SP-16-00155: A site plan for a phased, commercial development with multiple buildings for a mix of retail and quality restaurant and/or fast order food but excluding fast order food-drive-in uses located at 4300 W 24th Place. Submitted by Paul Werner Architects, for RPI, LLC, property owner of record.

ADMINISTRATIVE DETERMINATION: The Planning Director approves the above-described Site Plan with the requirement that prior to issuance of a building permit the applicant shall provide building elevations and photometric plans for staff review and approval and subject to the following conditions:

Figure 1: Interior vehicular pattern

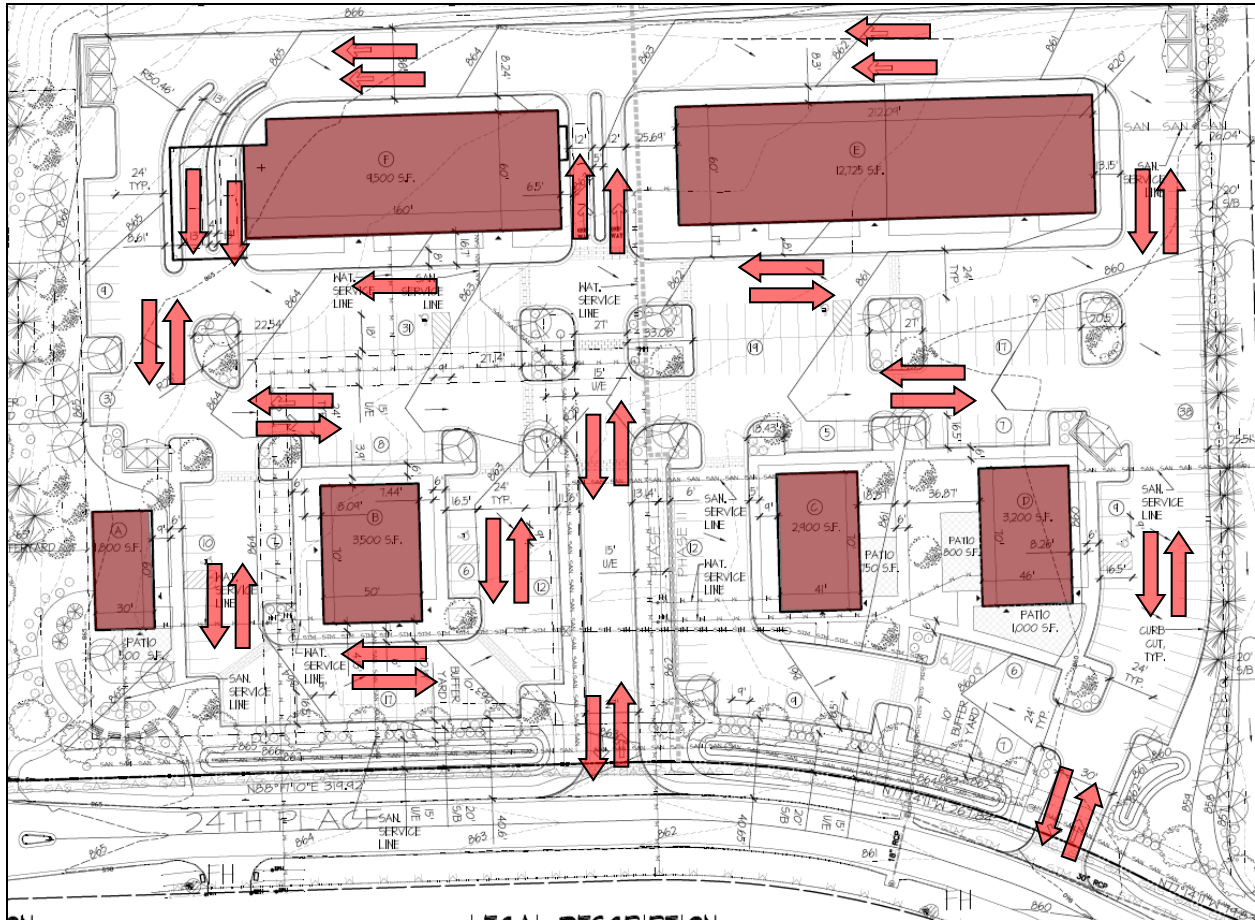
The City Engineer noted that the drive-thru window locations may need to be adjusted based on future review of the tenant space to ensure vehicle stacking requirements are met. The proposed or future bank use located on the west end of Building F appears to provide adequate stacking. The use on the east end of the building may or may not require additional stacking depending on the final tenant.

Figure 4: Inverness Drive Buffer Yard

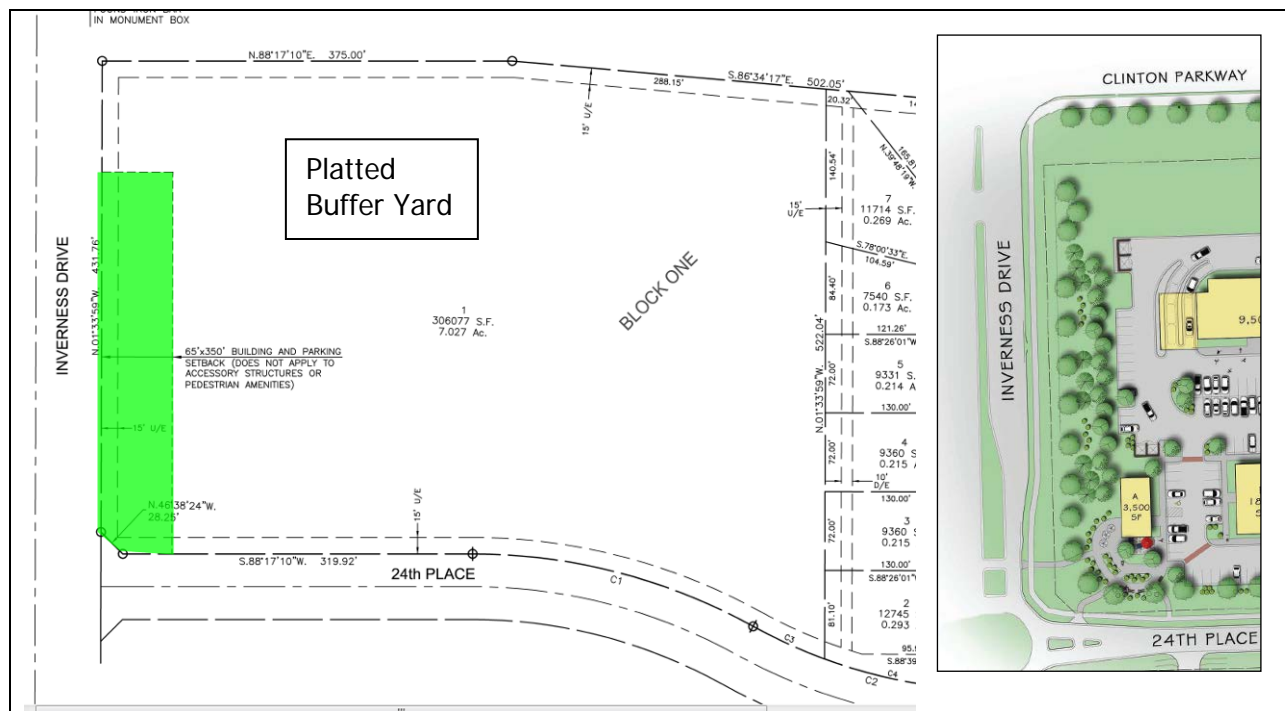
The plan exceeds the required landscape planting standards for screening along Inverness Drive.

Figure 7: Main Building Entrance

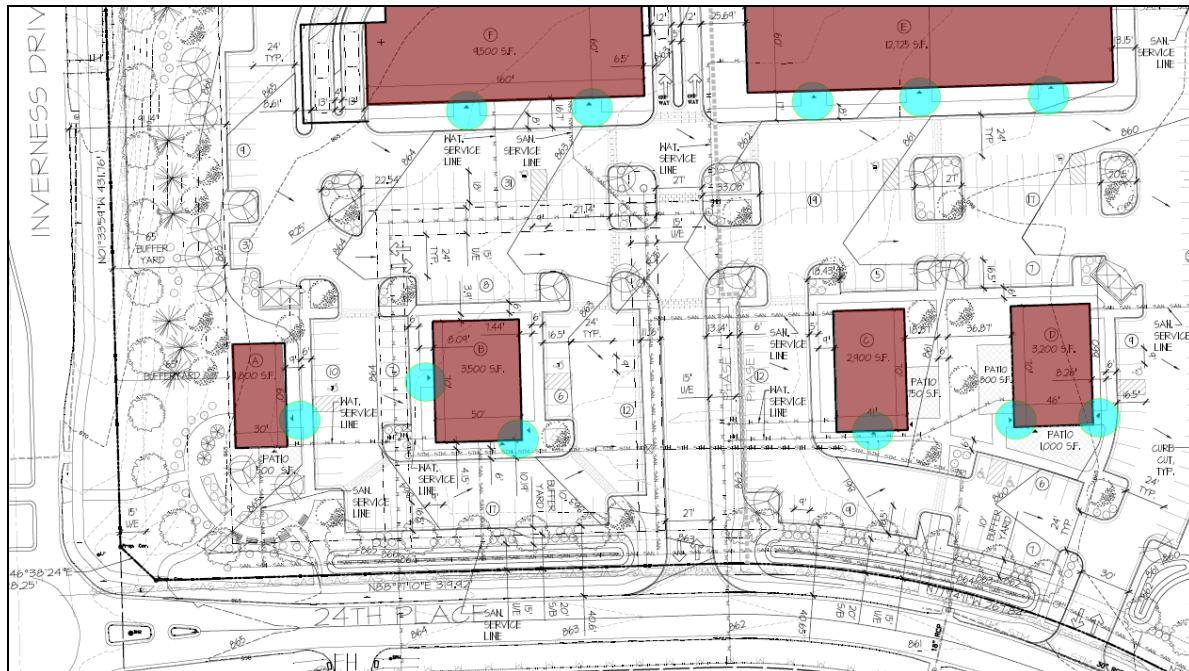
The CN2 district does not allow off-street parking between the street and the main entrance of a building. This standard applies to Buildings A, B, C and D as shown on the site plan.

The building entrances are shown conceptually. As final building elevations are determined building entrances will need to be on the east/west sides of the buildings to comply with the design standard per Section 20-908.
